Subject: Carlsbad Field Office Class 1 Permit Modification Notifications to the Waste Isolation Pilot Plant Hazardous Waste Facility Permit Number: NM4890139088-TSDF

Class 1 Permit Modification Notifications

**Waste Isolation Pilot Plant
Carlsbad, New Mexico**

WIPP Permit Number - NM4890139088-TSDF

Figure A4-2
WIPP Traffic Flow Diagram

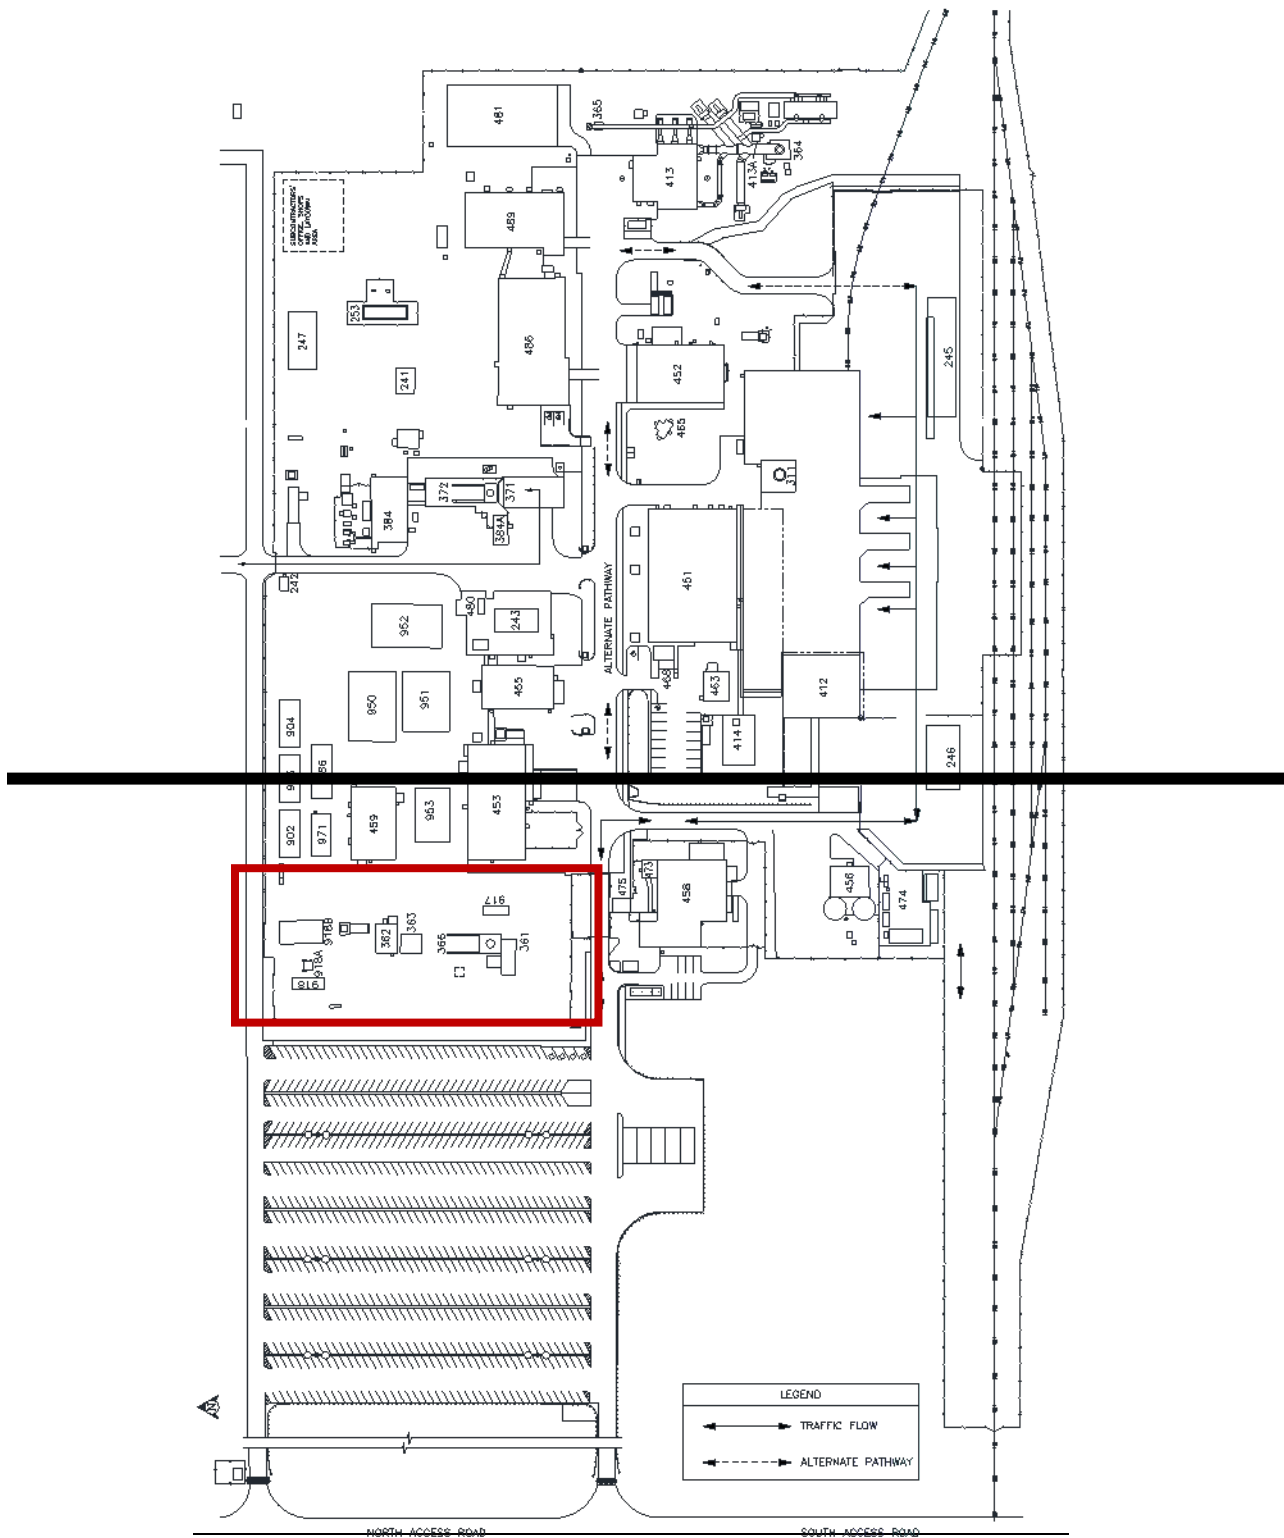
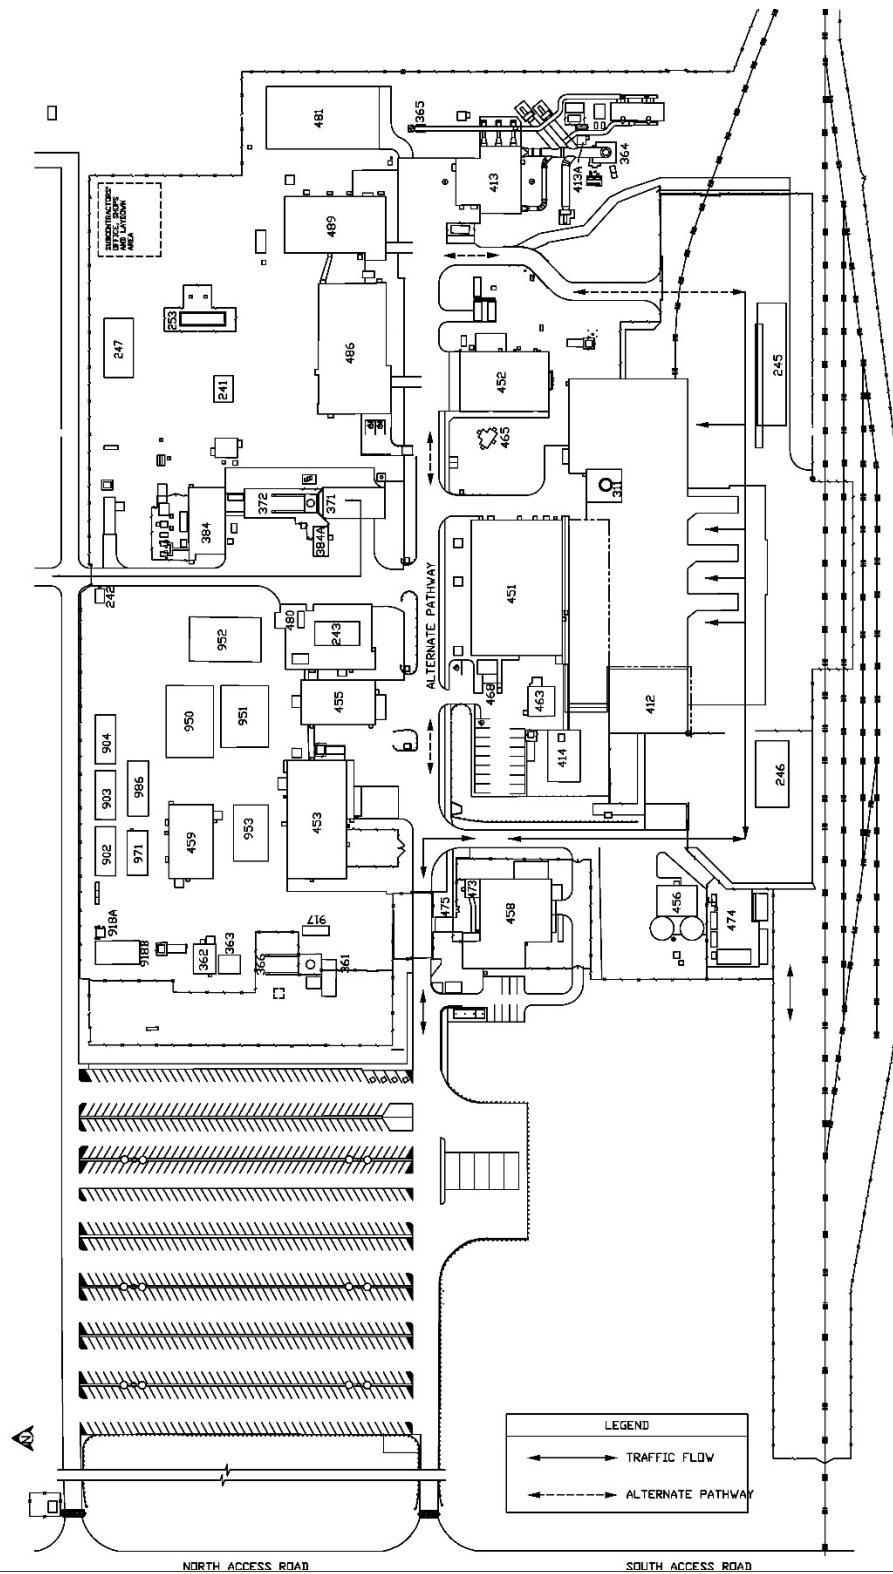
- Attachment A4, Figure A4-2, *WIPP Traffic Flow Diagram*
- Attachment D, Figure D-1, *WIPP Surface Structures*
- Attachment D, Figure D-5, *Fire-Water Distribution System*
- Attachment D, Figure D-6, *WIPP On-Site Assembly Areas and Off-Site Staging Areas*

- Attachment A4, Figure A4-2, *WIPP Traffic Flow Diagram*
- Attachment A4, Figure A4-2-NFB, *WIPP Traffic Flow Diagram with Building 416*
- Attachment D, Figure D-1, *WIPP Surface Structures*
- Attachment D, Figure D-1a, *Legend to Figure D-1*
- Attachment D, Figure D-1-NFB, *WIPP Surface Structures with Building 416*
- Attachment D, Figure D-1a-NFB, *Legend to Figure D-1-NFB (Building 416)*

A temporary fence has been constructed pursuant to Permit Part 2, Section 2.6.2., *Barrier*, in the northwest corner of the PPA to facilitate construction work at the Air Intake Shaft (**AIS**). The temporary fence is located within the current PPA fence as shown in the updated Figures A4-2, D-1, D-5, and D-6. The temporary barrier is seven feet high and topped with three strands of barbed wire for a total height of eight feet, and contains no normal access point or points of entry to the active portion of the facility (i.e., the portion of the facility where hazardous waste management activities are performed).

In the process of constructing the temporary fence, Building 918A was relocated to the northeast corner of building 918B and Building 918 was removed. All figures depicting the overall site layout have been updated to incorporate the new location of Building 918A and the removal of Building 918 for completeness and accuracy of the Permit.

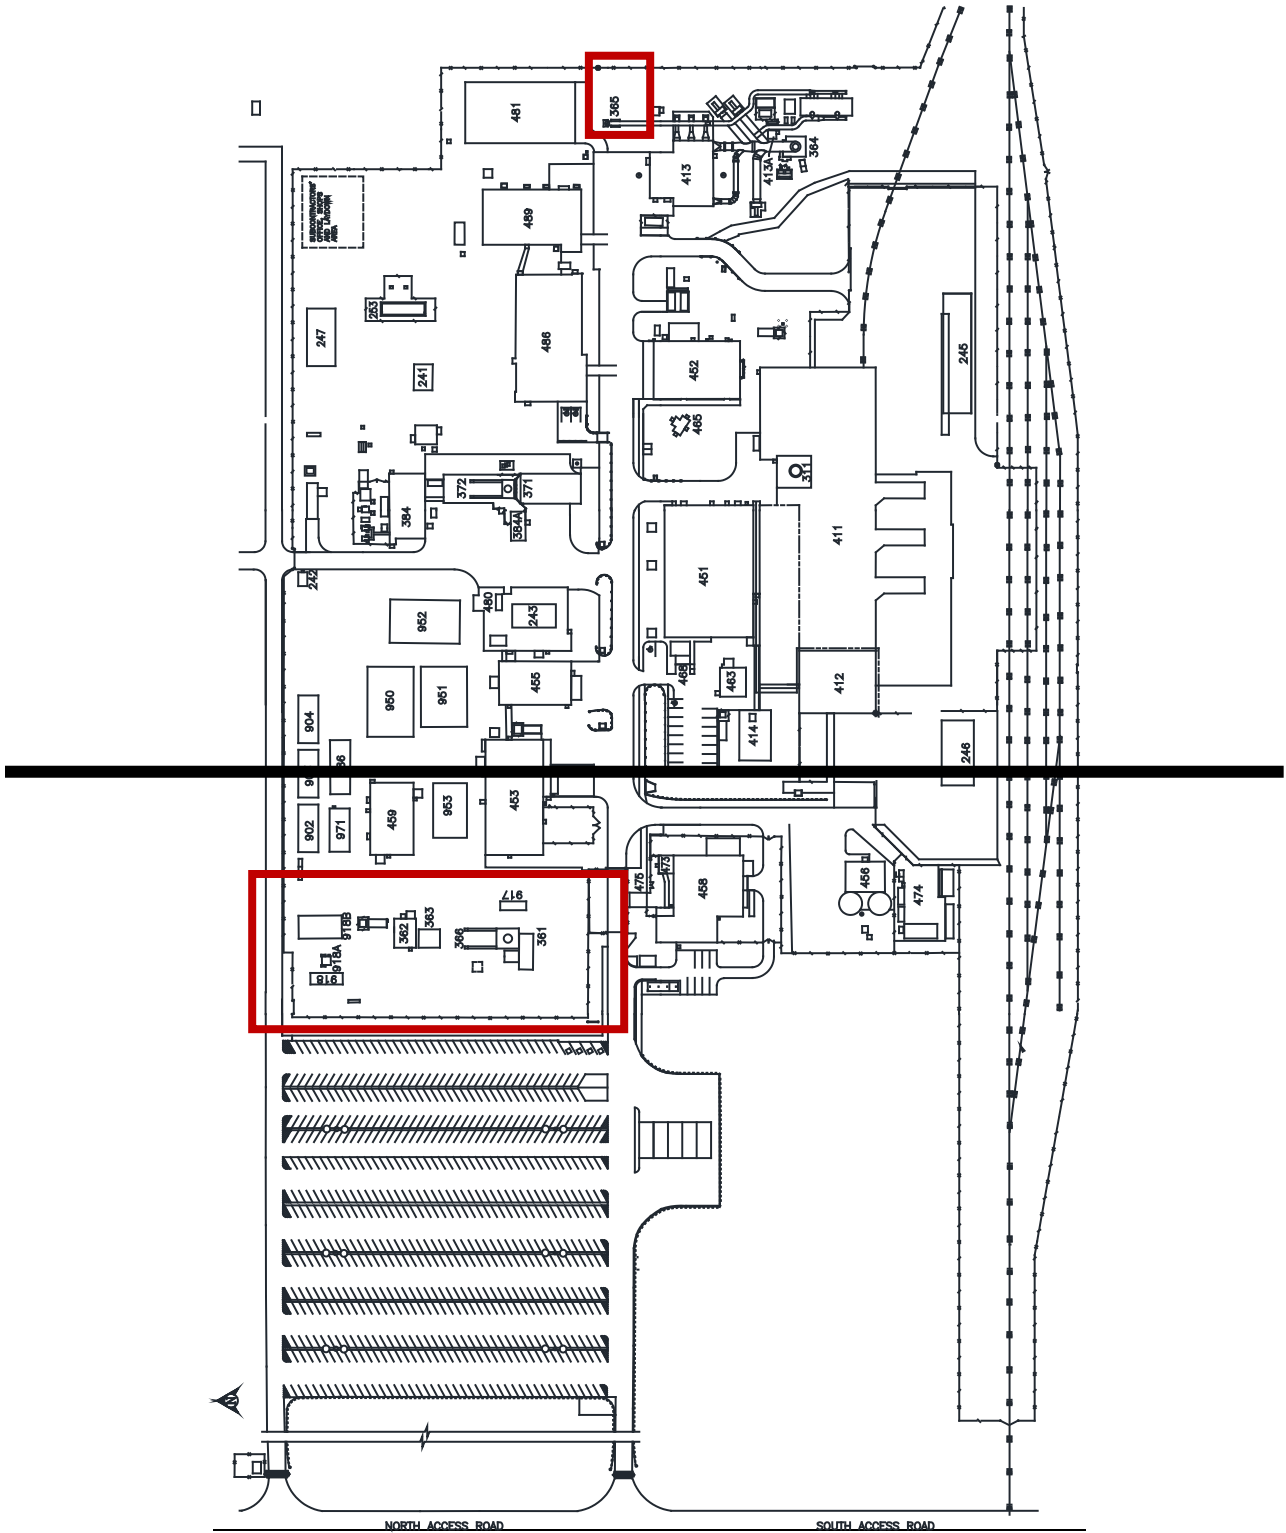
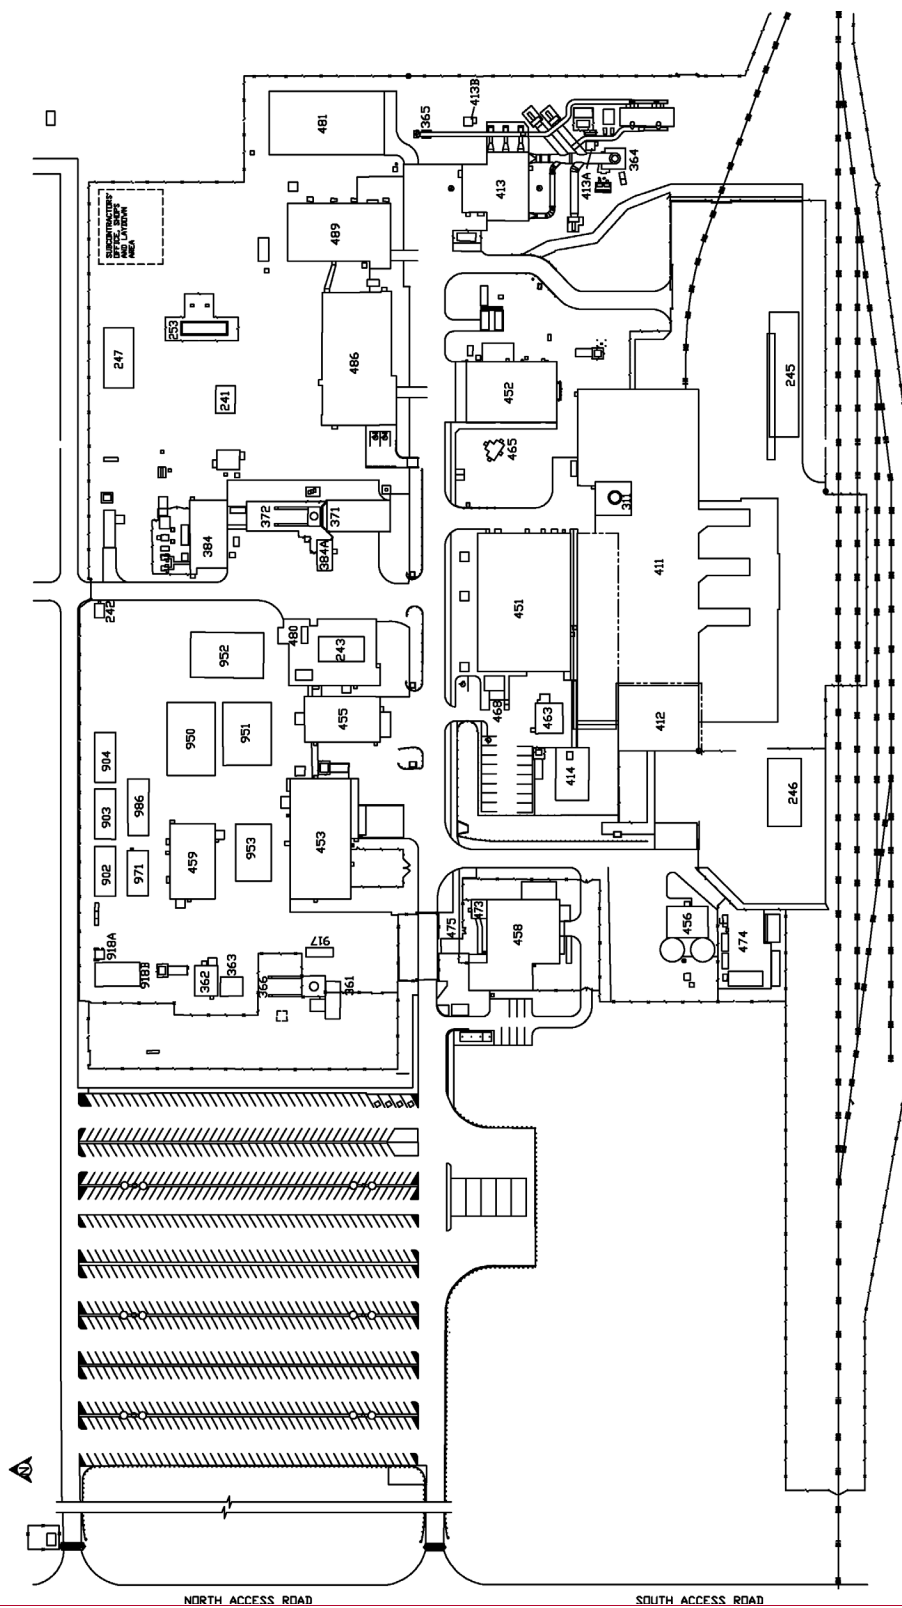
- Attachment D, Figure D-1, *WIPP Surface Structures*
- Attachment D, Figure D-1-NFB, *WIPP Surface Structures with Building 416*

Figures D-1 and D-1-NFB have also been updated to incorporate the labeling of Building 413B for completeness and alignment with the respective figure legends, Figures D-1a and D-1a-NFB. These changes are needed to ensure completeness and accuracy of the Permit.

Figure D-5
Fire-Water Distribution System

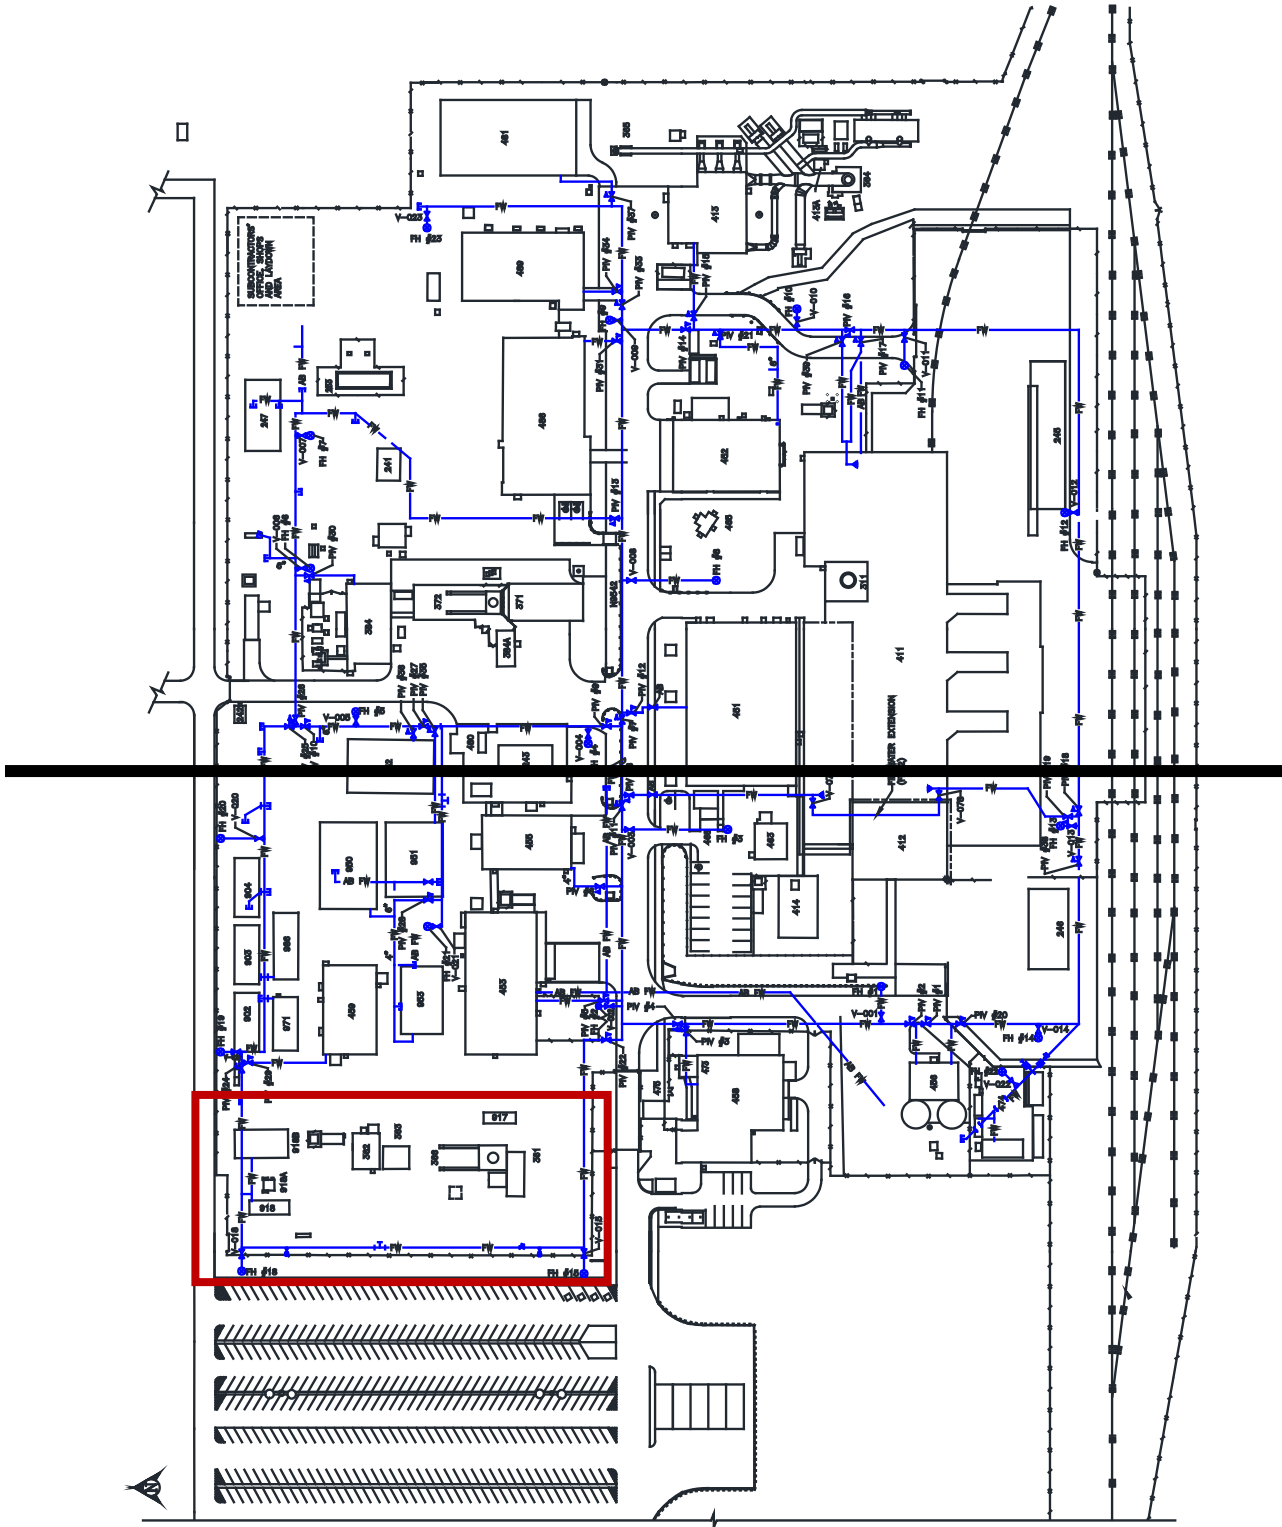
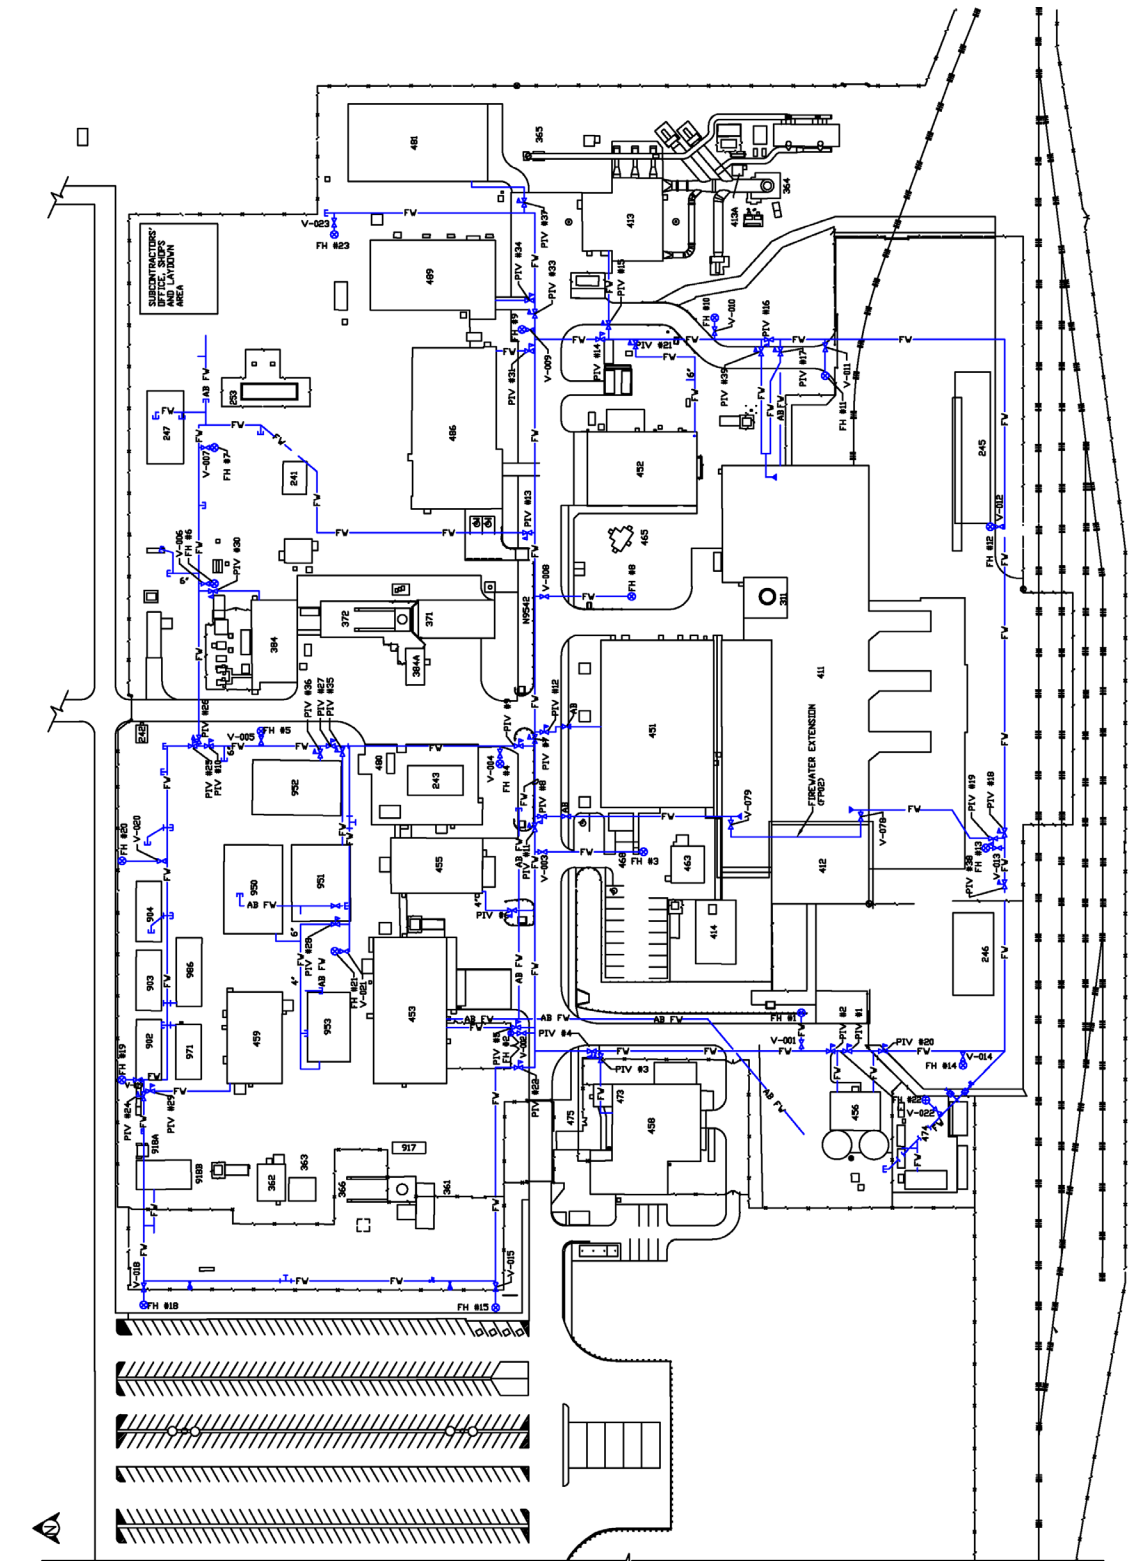
- Attachment D, Figure D-5, *Fire-Water Distribution System*
- Attachment D, Figure D-5-NFB, *Fire-Water Distribution with Building 416*
- Attachment D, Figure D-6, *WIPP On-Site Assembly Areas and Off-Site Staging Areas*
- Attachment D, Figure D-6-NFB, *WIPP On-Site Assembly Areas and Off-Site Staging Areas with Building 416*
